From: James, Andrew G - DNR
Sent: Wednesday, July 8, 2020 8:44 AM
To: 'Jason Powell'
Subject: Requested revisions to closure packet - 03-38-231379 - Kopatz / Cronce Property

Subject: Requested revisions to closure packet - 03-38-231379 - Kopatz / Cronce Property

As discussed on the phone yesterday, below are the revisions WDNR is requesting to your closure request. Please let me know if you have any questions or concerns.

B.2.a

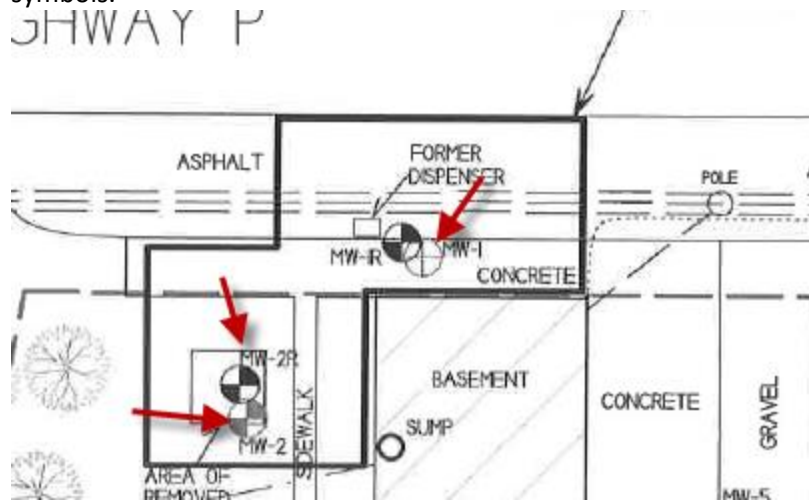
-Extend soil delineation further south under the building with a dashed line. When inferring delineation under the building, please use professional judgement that reasonably reflects the known remaining contamination adjacent to the building.

-Identify the Structural Impediment.
